CITY OF ALBUQUERQUE

**RE: Adams Artisan Coffee Building
11840 Cochiti Road NE
Grading and Drainage Plans
Engineer's Stamp Date: 06/03/2025
Hydrology File: L21D058
Case # HYDR-2025-00198**

11850 COCHITI ROAD SE
ADAMS ARTISAN COFFEE BUILDING
ALBUQUERQUE, NM 87123
GRADING & DRAINAGE PLAN

SHEET NO:
CG-101

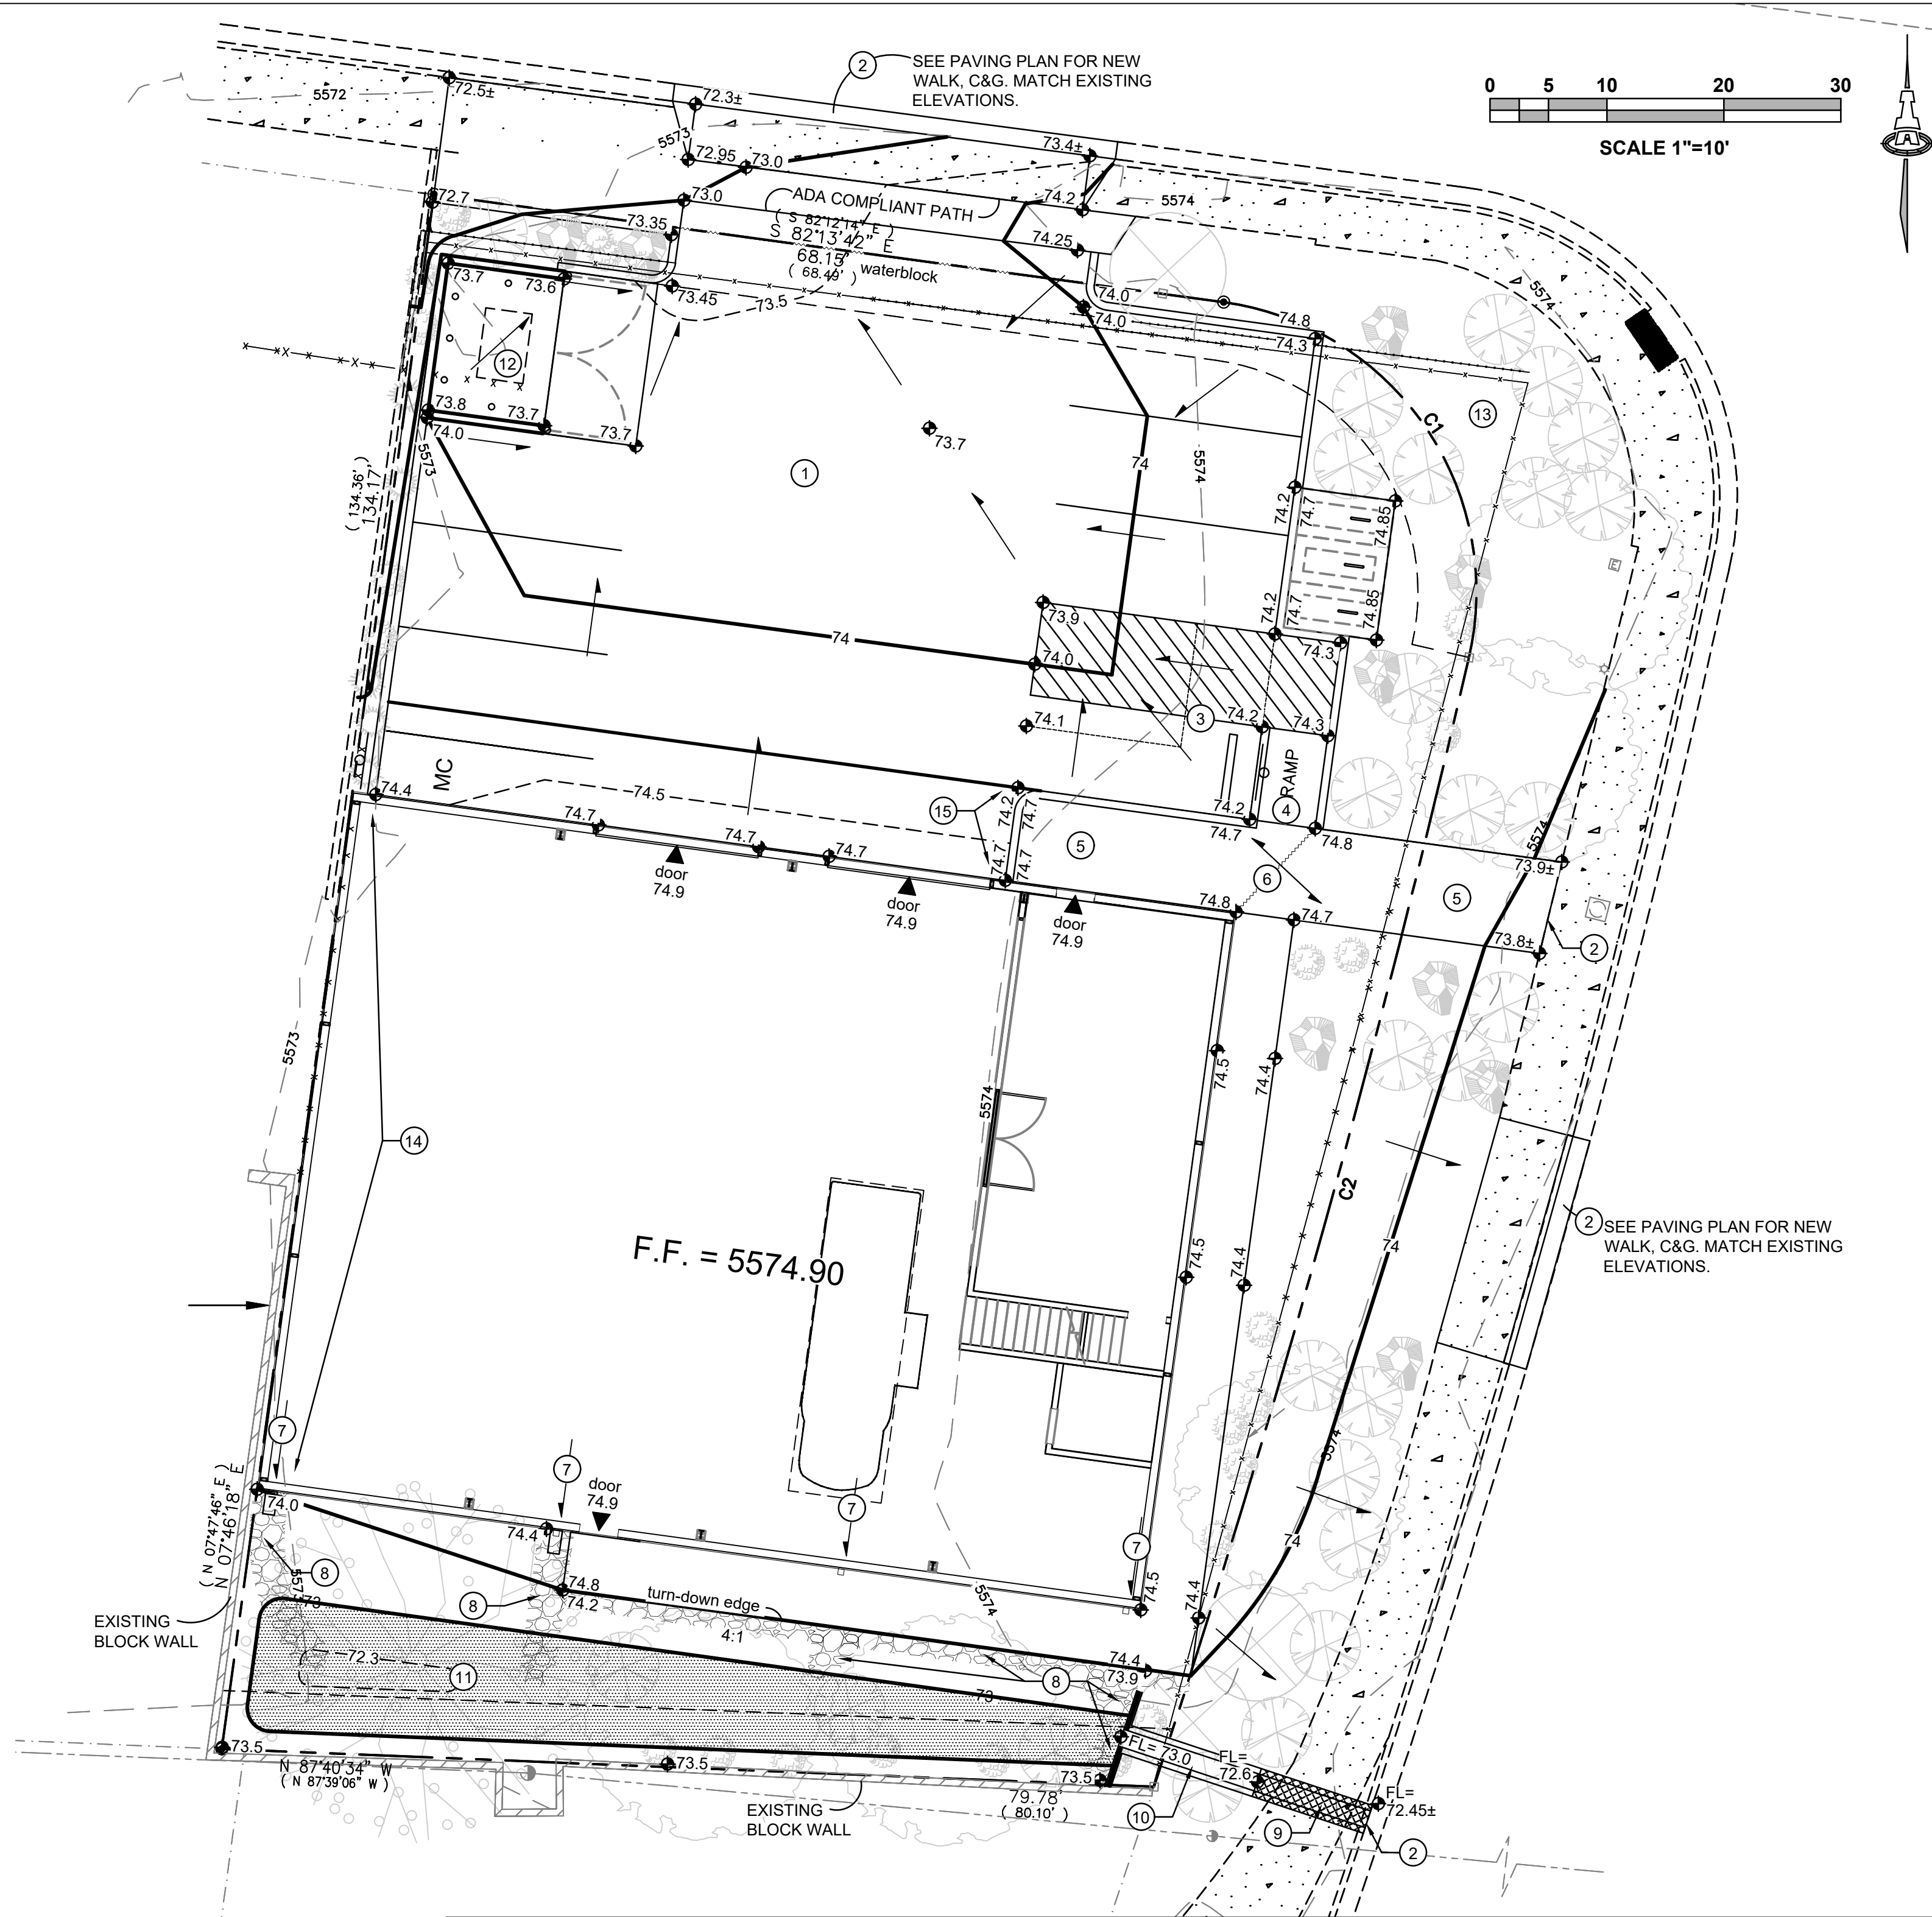
Based upon the information provided in your submittal received 06/03/2025, the Grading & Drainage Plan is approved for Grading Permit and Building Permit. Please attach a copy of this approved plan in the construction sets for Building Permit processing along with a copy of this letter.

1. Engineer's Certification, per the DPM Part 6-14 (F): *Engineer's Certification Checklist For Non-Subdivision* is required.
2. Please provide the executed paper Drainage Covenant (latest revision) printed on one-side only with Exhibit A and a check for \$25.00 made out to "Bernalillo County" for the stormwater quality pond per Article 6-15(C) of the DPM to Hydrology for review at Plaza de Sol. An Application for Covenant in ABQ-PLAN is also required to process the submittal.
